M25 J10/A3 Wisley interchange TR010030

9.117 Applicant's comments to Deadline 10 Submissions

9.117 Applicant's comments to Deadline 10 Submissions

Figure 1 Representation of the probable positioning of the trench

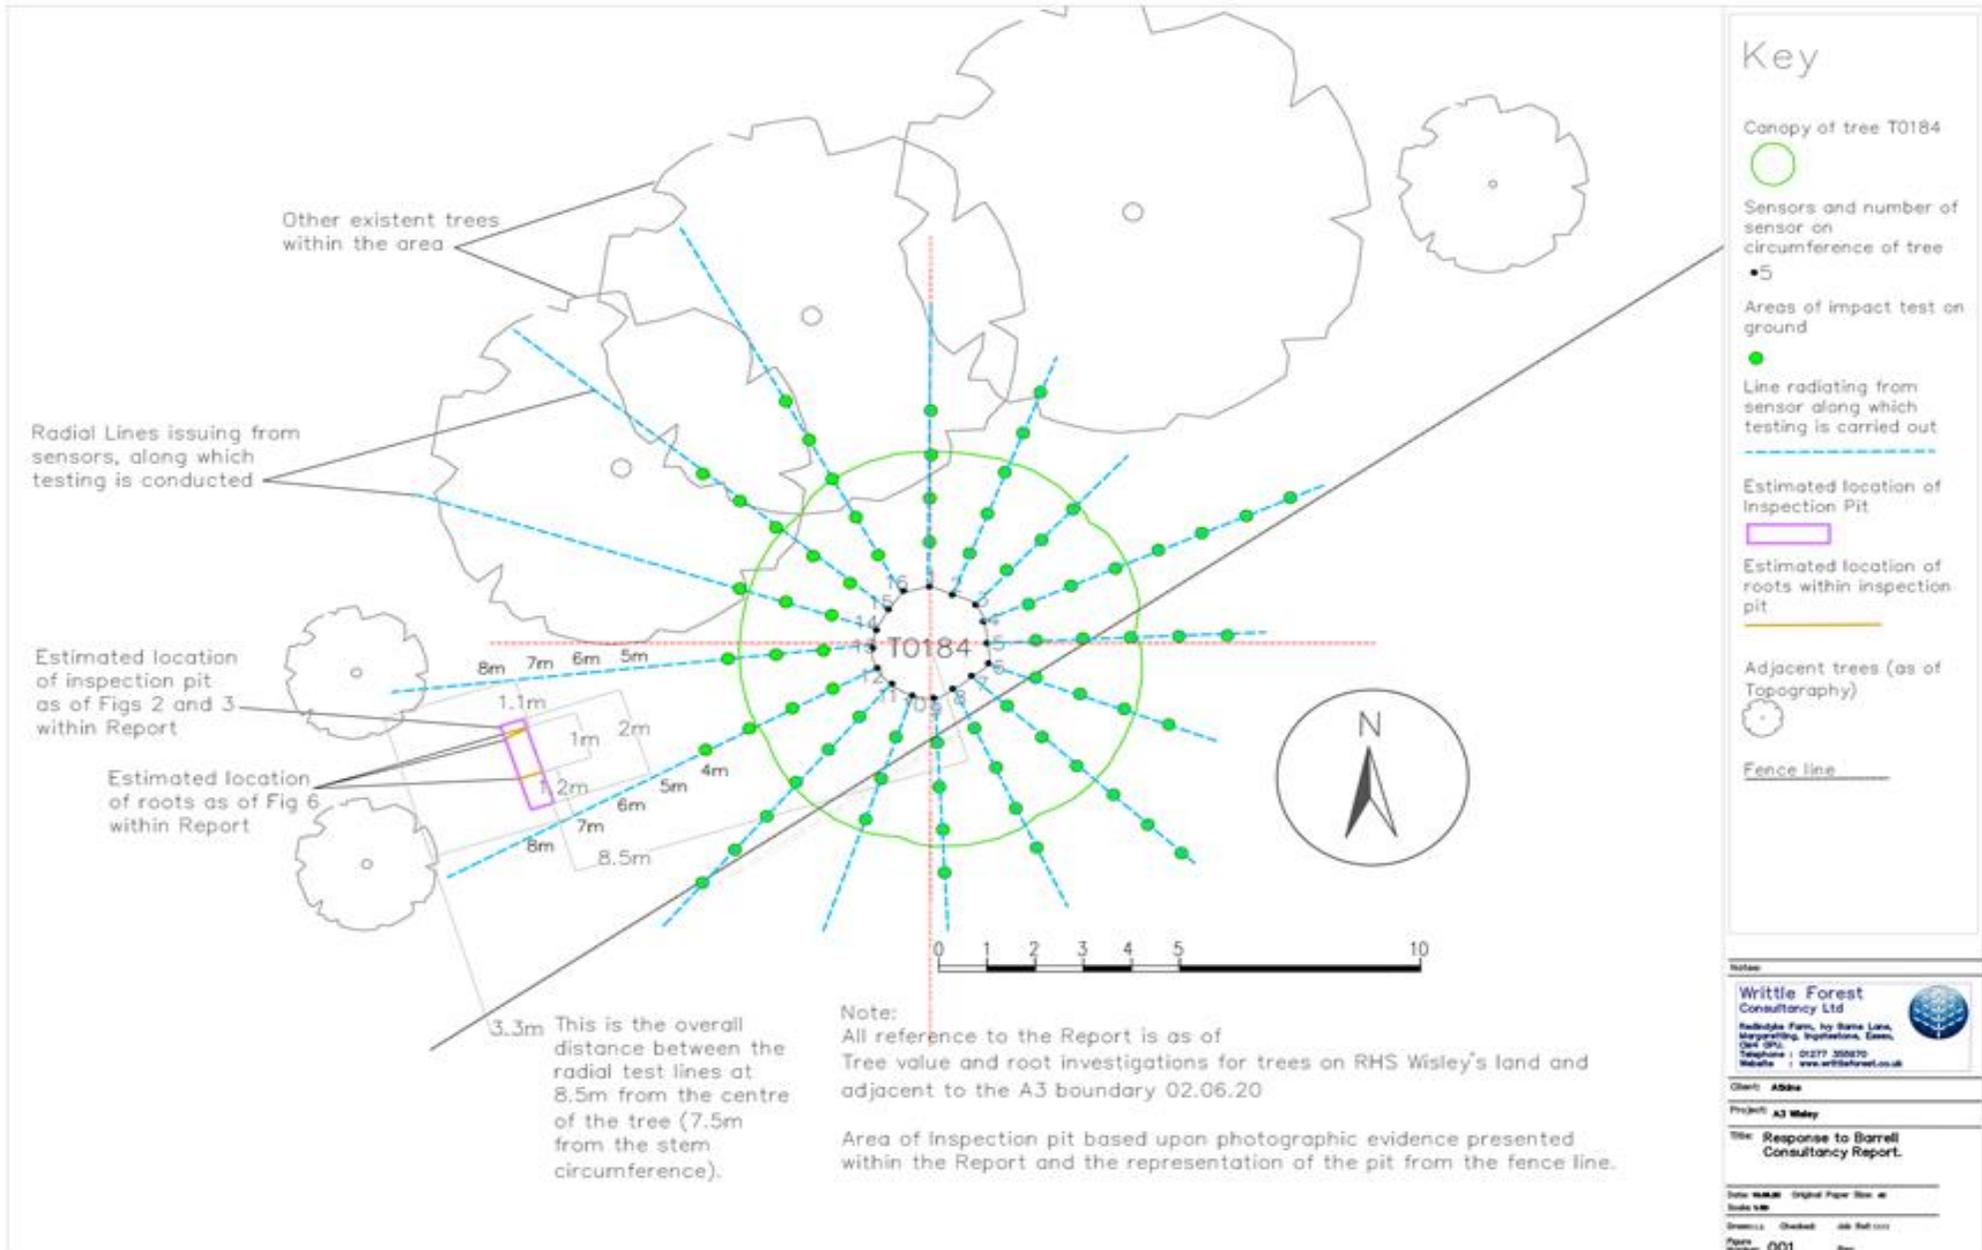
- 7.1.7 Mr Barrell's critique of the root mapping exercise is based on the investigative trench shown within the BTC report [REP10-034]. In Highways England's opinion the map (Figure 3) within the BTC report is an inaccurate representation of the position of the investigative trench. The radial lines at which the testing occurred

were based upon the locations of the sensors on the base of the tree. These positions could have been ascertained from the technical note submitted as part of deadline 8, based on the orientation and the spacing at which the sensors were placed on the tree. The BTC report relates the position of the trench in relation to the fence line. This fence line is not accurately presented in Figure 3 of the BTC report [REP10-034]. The plan at Appendix A of this document is based on the information provided in the BTC report. The plan attempts to provide a more accurate representation of the probable position of the trench in relation to the testing undertaken by Highways England.
